TECHNICAL MEMORANDUM 001
Potential City Council Modifications
River North (formerly Liberty Towers)
CEQR No. 20DCP140R

ULURP Nos.: C 210289 ZMR, N 210290 ZRR, C 210291 ZSR
29 October 2021

River North (Liberty Towers) Technical Memo
Modified Project Drawings
Prepared by FXCollaborative

Figure 1: Modified Rezoning Area

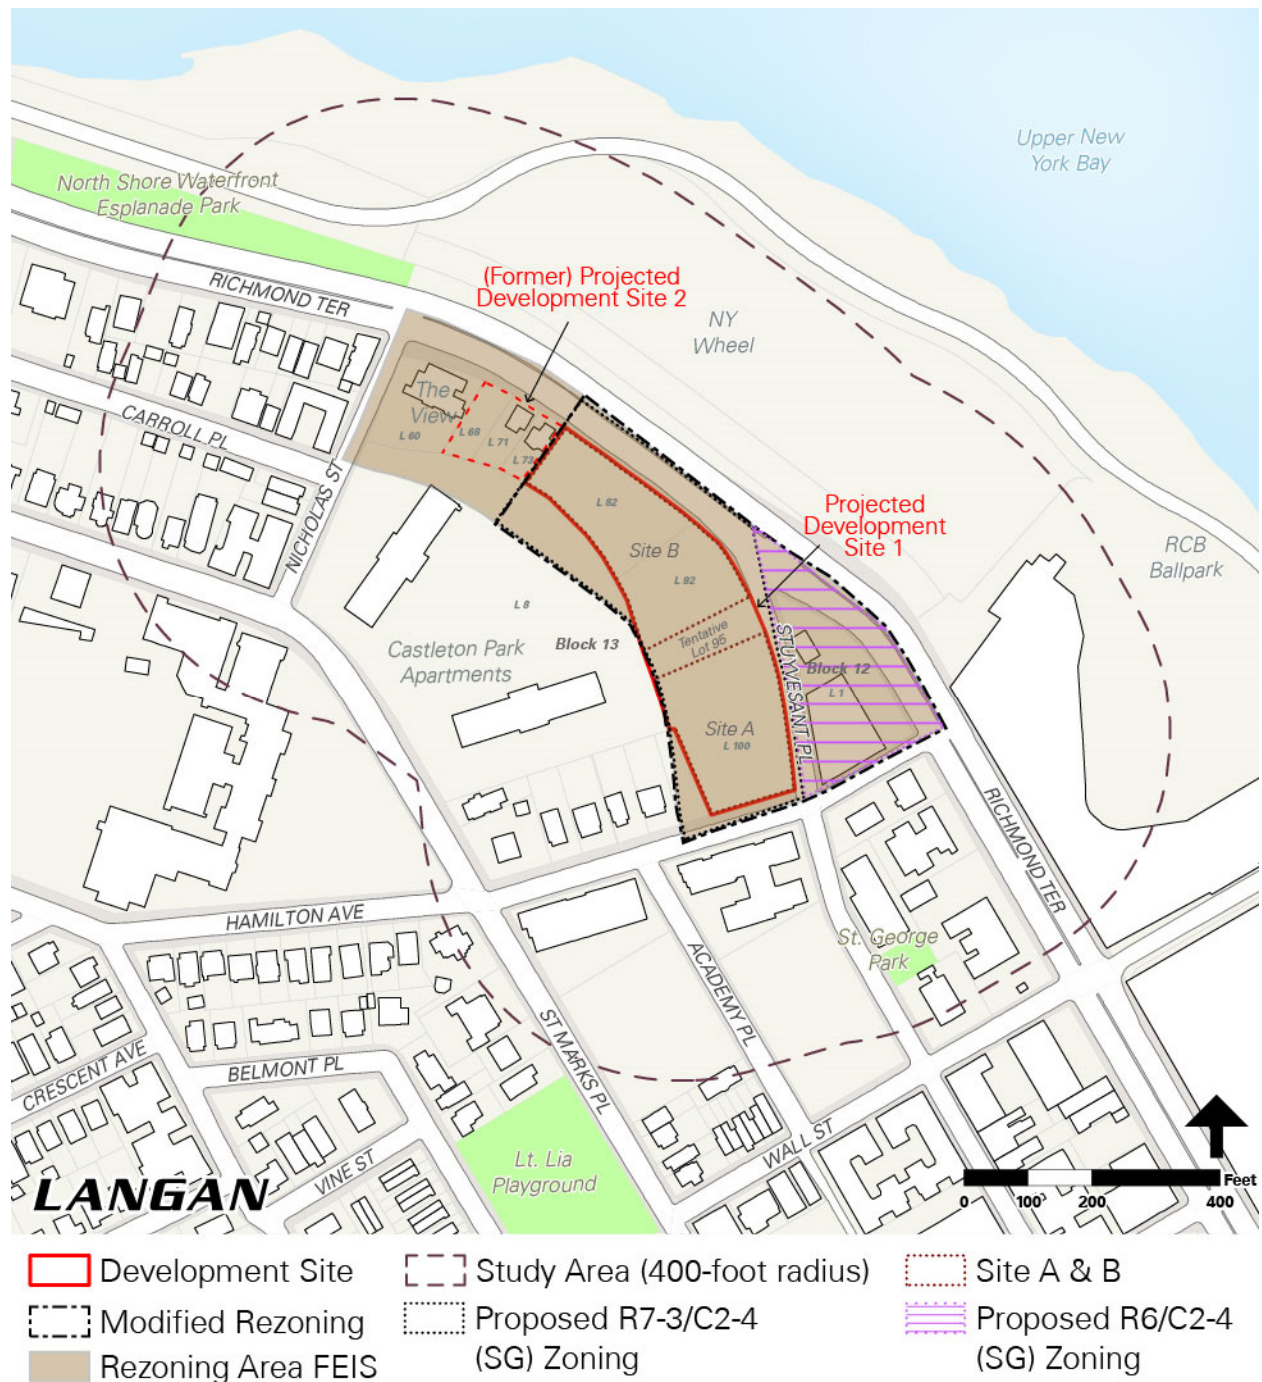
The Modified Actions would remove Projected Development Site 2 from the Rezoning Area and reduce the heights of Buildings 1, 2, and 3 on Projected Development Site 1 to maximum roof heights (top of roof) to 173.03 feet, 104.64 feet, and 132.14 feet, respectively. The height modifications to the buildings on Projected Development Site 1 would result in a reduction of floor area and dwelling units and the reconfiguration of parking facilities.

Figure 1 shows the Modified Rezoning Area, and Table 1 shows the change in programming between the FEIS and the programming that is projected to result from the Modified Actions. The special permit drawings for the Modified Project are provided in Appendix A.

Figure 2: Modified Building Massings

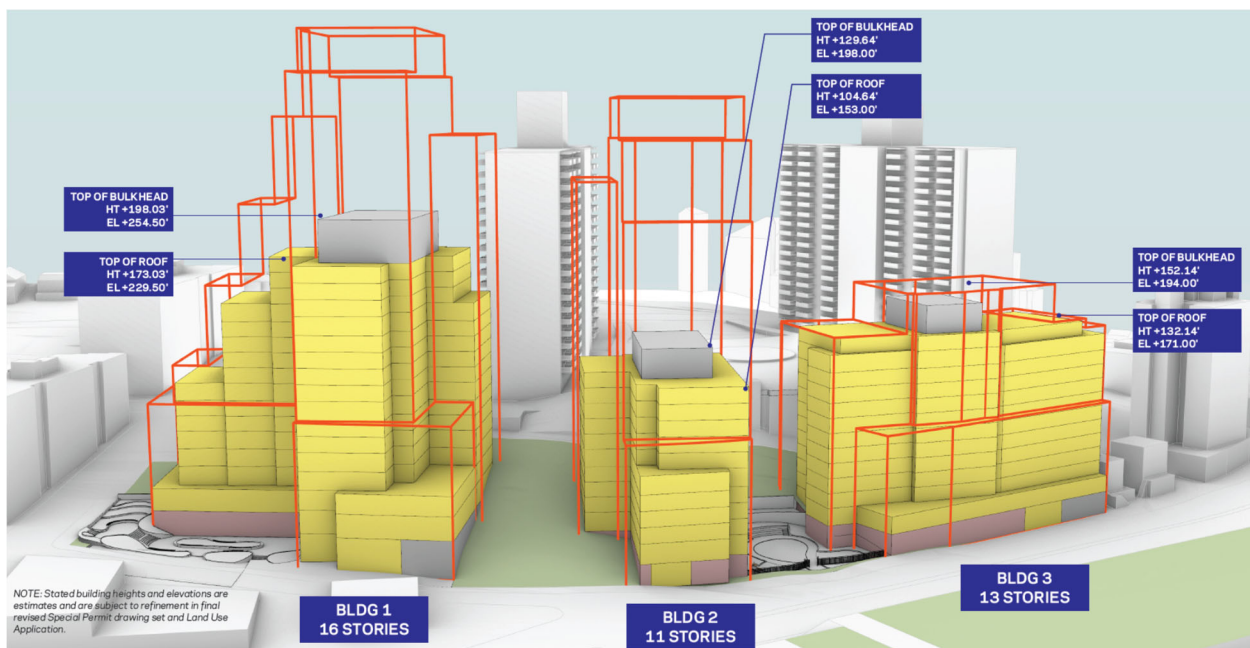
Figure 2 shows the building bulk that would result on Projected Development Site 1 from the Modified Actions; the Modified Project would be wholly within the building envelopes analyzed in the FEIS.

Note: The red lines show the maximum building envelopes analyzed in the FEIS.

Figure 3: HVAC and Hot Water Emissions from Building 1

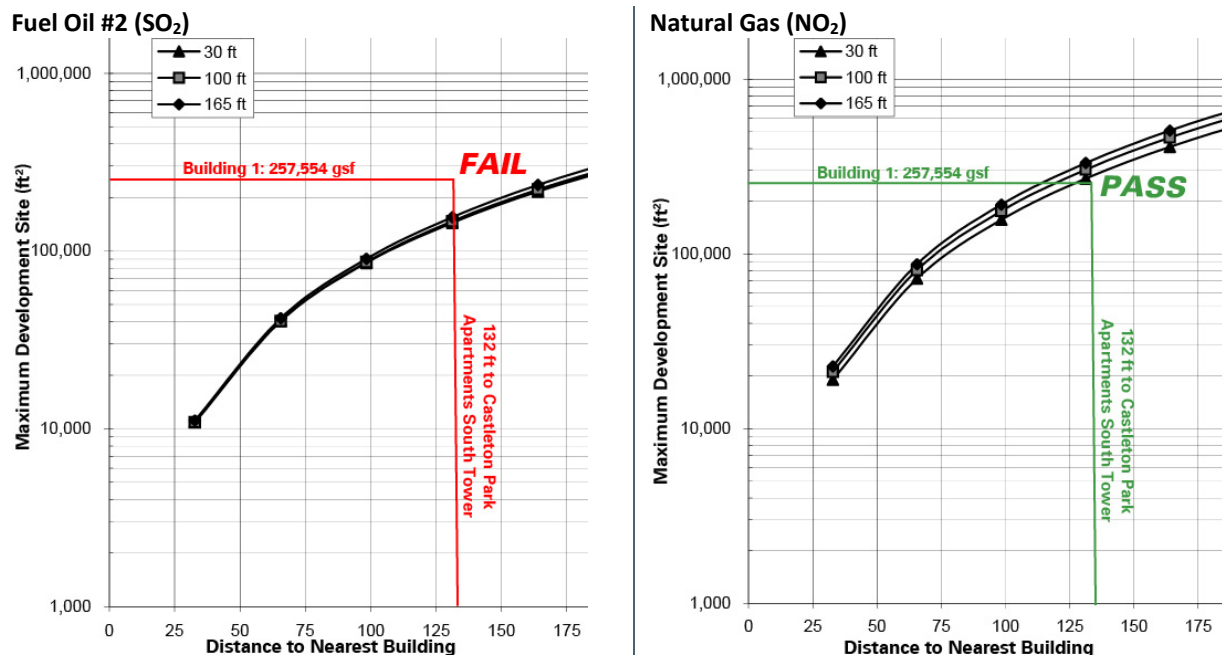
Because Building 1's emissions stack would be at 195 feet above grade and below the elevation of the sensitive receptors at the Castleton Park Apartments South Tower, an HVAC screening was warranted. Building 1 would contain 257,554 gsf of non-parking floor area (the parking area would not be served by the building's HVAC system). The bulkhead would be at least 127 feet from the nearest façade of the Castleton Park Apartments; because Building Code requires the emissions stack be at least 5 feet from the roof edge, the emissions stack on Building 1 will be at least 132 feet from the Castleton Park Apartments South Tower. The HVAC screenings for Building 1 are provided in Figure 3.

Figure 4: HVAC and Hot Water Emissions from Building 2

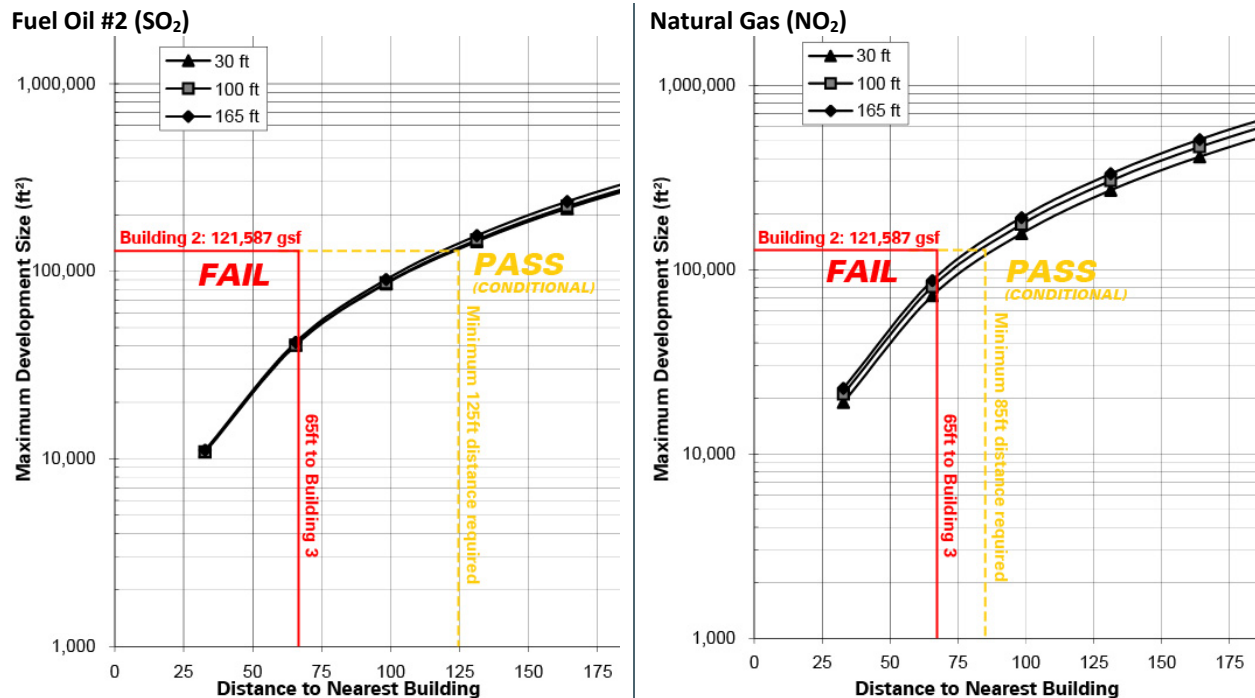
Building 2 would have a bulkhead height of approximately 125 feet in the Modified Project, and an emissions release point of approximately 128 feet. The nearest receptor of similar or greater height to the building's bulkhead would be Building 3 at a minimum distance of 60 feet. When incorporating the 5-foot setback from the roof edge that is required by Building Code, Building 2's emissions stack would be at least 65 feet from Building 3. Building 2 would contain 121,587 gsf of floor area that would be served by the building's HVAC and hot water systems. Building 2's nomographs for both natural gas and fuel oil #2 are shown in Figure 4.

The nomograph shows that Building 2 would fail the screening with the use of fuel oil #2 if the emissions stack is located within 125 feet of a building of similar or greater height, or within 85 feet if natural gas is used. Because of the configuration of the proposed buildings and the location of Building 2's bulkhead, it may not be possible to site the emissions stack more than 125 feet from a receptor of similar or greater height. Portions of Building 2's bulkhead would be at least 85 feet from a receptor of similar or greater height and 5 feet from the bulkhead's edge. Accordingly, an E-Designation would be warranted specifying that the emissions stack on Building 2 be located at the highest tier at least 128 feet above grade and at least 85 feet from a receptor of similar or greater height.

Figure 5: HVAC and Hot Water Emissions from Building 3

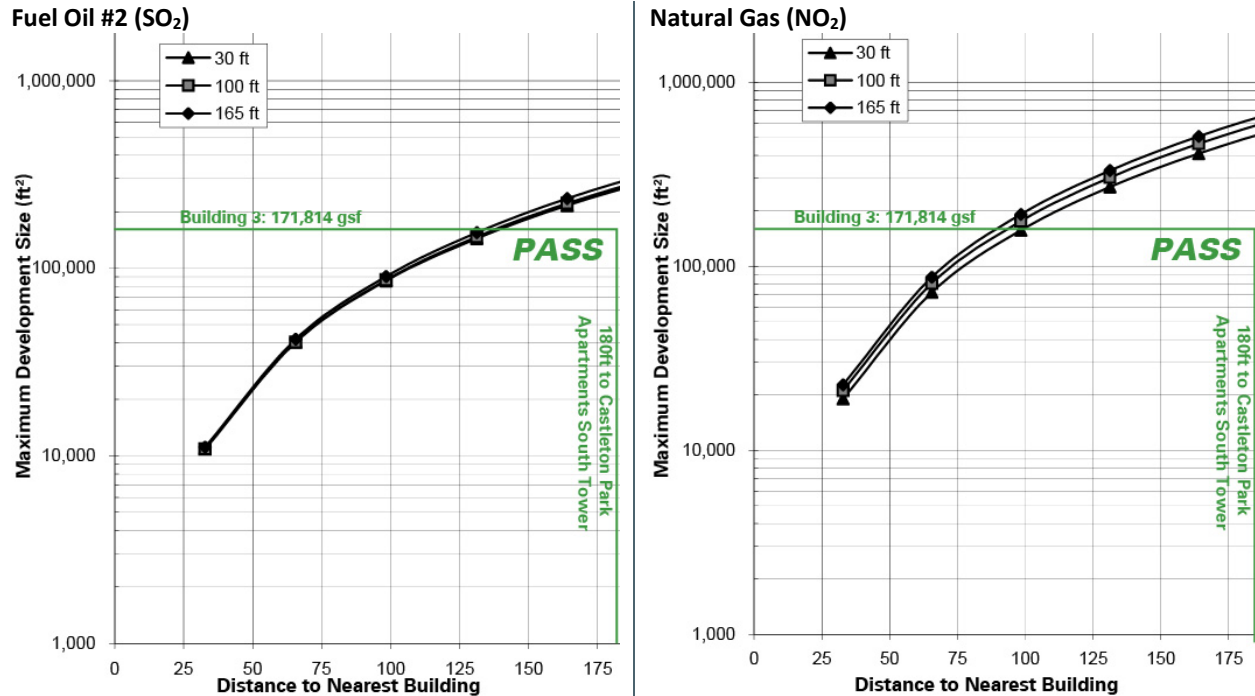
Building 3 would have a bulkhead height of approximately 152 feet in the Modified Project, and an emissions release point of approximately 155 feet. The nearest receptor of similar or greater height to the building's bulkhead would be the Castleton Park Apartments North Tower at a minimum distance of 180 feet, or 185 feet including the required 5-foot setback from the bulkhead's roof edge. Building 3 would contain 171,814 gsf of floor area that would be served by the building's HVAC and hot water systems. Building 3's nomographs for both natural gas and fuel oil #2 are shown in Figure 5.

The nomographs show that Building 3 would pass the screening with the use of either fuel oil #2 or natural gas if the emissions stack is located at the highest tier at least 155 feet above grade. Accordingly, and E-Designation would be warranted for Building 3 specifying that the emissions stack must be located at the highest tier.

Figure 6: HVAC and Hot Water Cumulative Emissions from Buildings 2 and 3

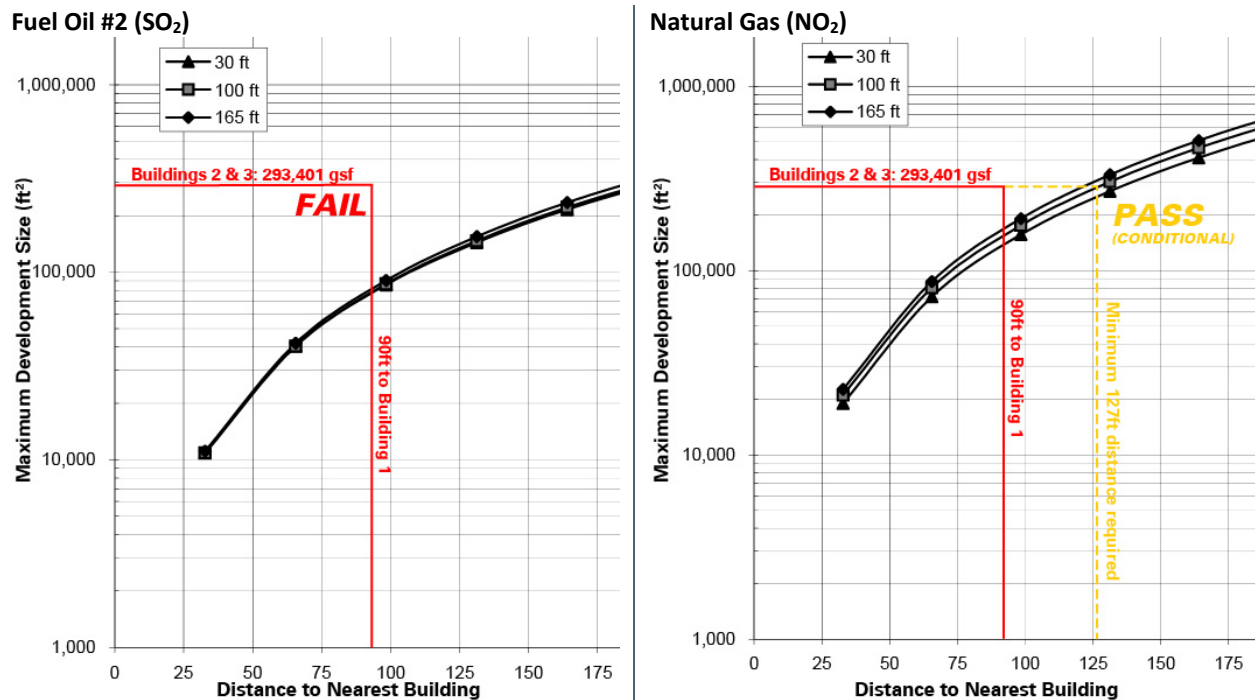
In the Modified Project, Buildings 2 and 3 would be of similar height and have the potential to result in cumulative emissions at nearby receptors of similar or greater height. Combined, Buildings 2 and 3 would contain 293,401 of floor area that would be served by the buildings' HVAC and hot water systems. The nearest receptor of similar or greater height to either Building 2 or 3 would be Building 1 at a minimum distance of 60 feet from Building 2; however, as currently contemplated, Building 2's bulkhead would be at least 90 feet from Building 1 at the emissions height. The nomograph showing the cumulative emissions from Buildings 2 and 3 on Building 1 are shown in Figure 6.

The nomograph of cumulative emissions from natural gas-powered systems in Buildings 2 and 3 show that the emissions stack on Building 2 must be sited at least 127 feet from Building 1 at the emissions height. Accordingly, an E-Designation is warranted for Building 2 specifying that the emissions stack be located at the highest tier and at least 127 feet from Building 1. Because Building 2 also warrants an E-Designation specifying the stack must be at the highest tier and at least 85 feet from Building 3, to account for cumulative emissions, an E-Designation is warranted specifying that:

- HVAC and hot water systems must use natural gas as a fuel source;
- the emissions stack on Building 2 must be located at the highest tier; and
- the emissions stack be located at least 85 feet from Building 3 and at least 127 feet from Building 1.
